*Iron Design L.L.C.*  
Added information for sheet (2) please note change to hole hole call outs for strut spar metal straps.

SIZE	DWG. NO.	rev
A	1 of 2- for sheet 2	B
SCALE:1:50	WEIGHT:	SHEET 1 OF 1

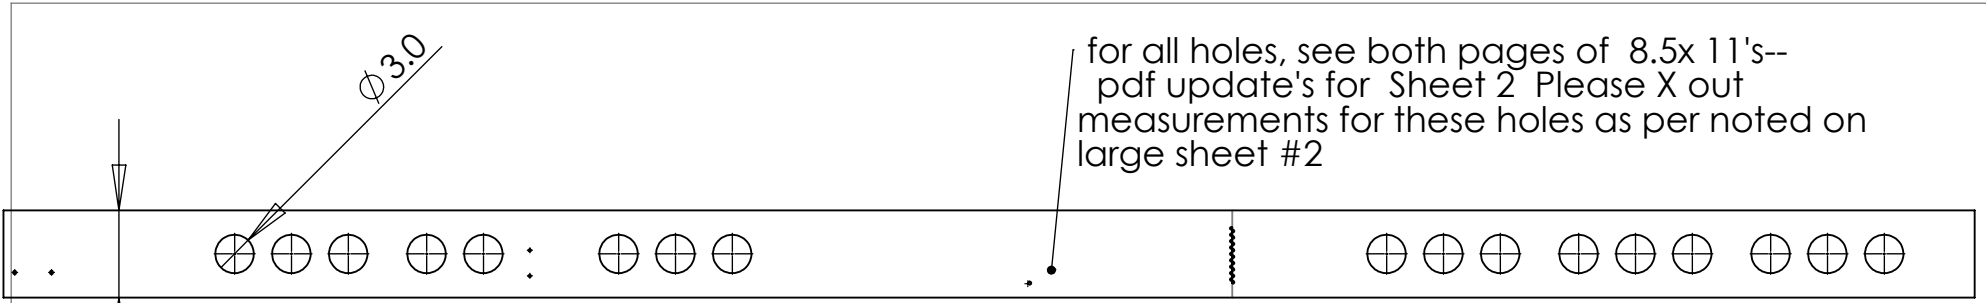
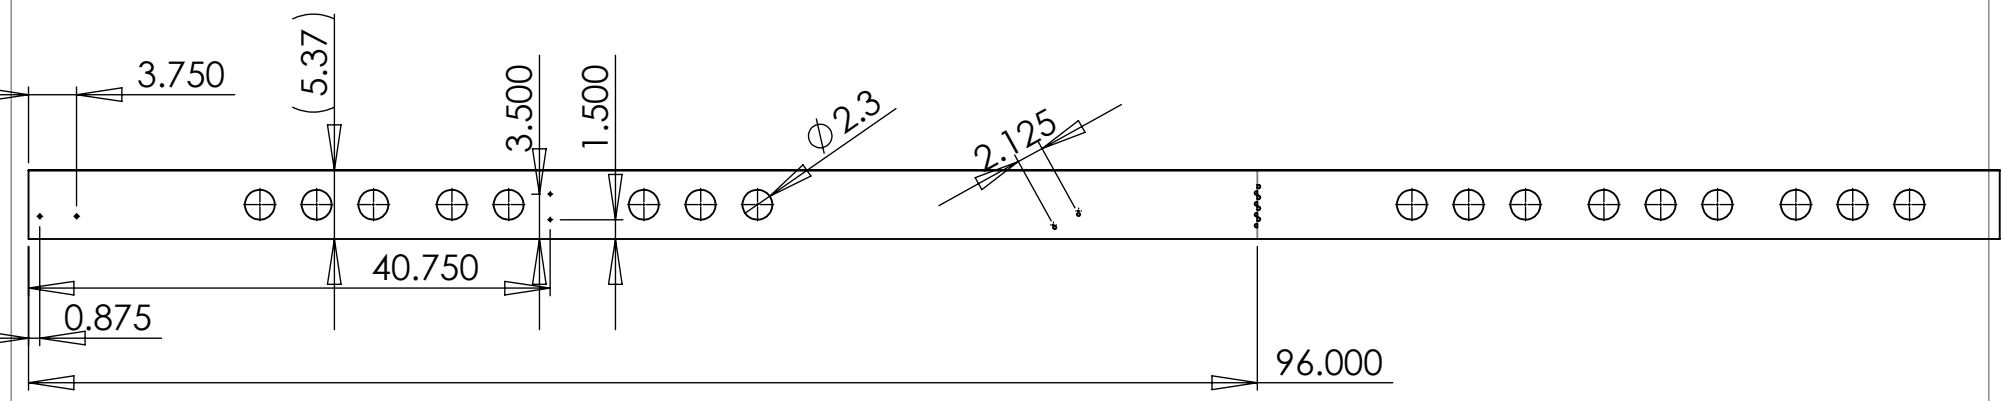
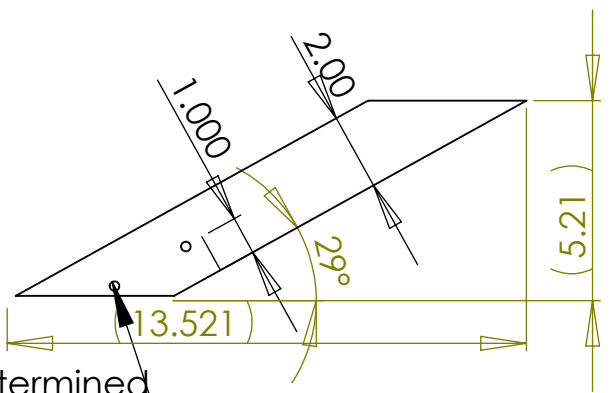
for all holes, see both pages of 8.5x 11's-- pdf update's for Sheet 2 Please X out measurements for these holes as per noted on large sheet #2

Front and rear spar fill in blocks, have .250 holes they are on center line from bottom to top as shown by 1" measurement  
Only drill these holes when all parts are in place. (as shown by second revision sheet- 8.5 x 11")

determined by strut attach bar measurements see sheet 2 of 2 8.5 x 11"
